Access Compliance Report Public Rights-of-Way (Curb Ramps)

Intersection ID: 43206Main Street: CALLAHAN_MILL_DRCross Street: ERWIN_TRACE_DRLocation:SEADA ID: 5C22E7E232F8Ramp Type: BlendTrans2Initial Pass/Fail: Fail Overall Compliance: NoSeverity Score: 10

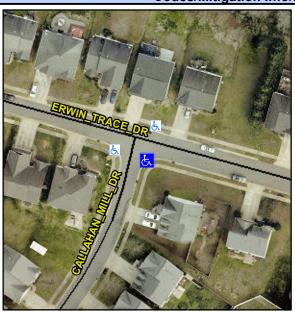
R304.5.1, R304.5.3

Compliance Description		Data	Compliance Description		Data
N/A	Ramp Length (in)	51.0	Yes	BlendTrans Slope (%)	4.7
No	Ramp Width (in)	47.5	No	BlendTrans XSlope (%)	4.3
N/A	Flare Type LT	N/A	N/A	Flare Type RT	N/A
N/A	Flare Slope LT (%)	N/A	N/A	Flare Slope RT (%)	N/A
N/A	Flare Traversable LT?	N/A	N/A	Flare Traversable RT?	N/A
N/A	Landing Length (in)	N/A	N/A	DWS Provided?	N/A
N/A	Landing Width (in)	N/A	N/A	DWS Contrast?	N/A
N/A	Landing Slope (%)	N/A	N/A	DWS Length (in)	N/A
N/A	Landing X Slope (%)	N/A	N/A	DWS Full Width?	N/A
N/A	Landing Curb? (Y/N)	N/A	N/A	DWS Offset (in)	N/A
N/A	Shared Landing?	N/A			
N/A	Gutter Ponding?	N/A	N/A	Gutter Slope (%)	N/A
N/A	Gutter Lip Ht (in)	N/A	N/A	Gutter X Slope (%)	N/A
N/A	Painted X Walk1?	No	N/A	Painted X Walk2?	No
	X Walk 1 Direction	To N		X Walk 2 Direction	To W
	X Walk 1 Width (in)	N/A		X Walk 2 Width (in)	N/A
	X Walk 1 Slope (%)	1.5		X Walk 2 Slope (%)	1.2
	X Walk 1 X Slope (%)	2.2		X Walk 2 X Slope (%)	3.2

Remove & Replace Curb Ramp With
Two New Directional Ramps or
Equivalent.
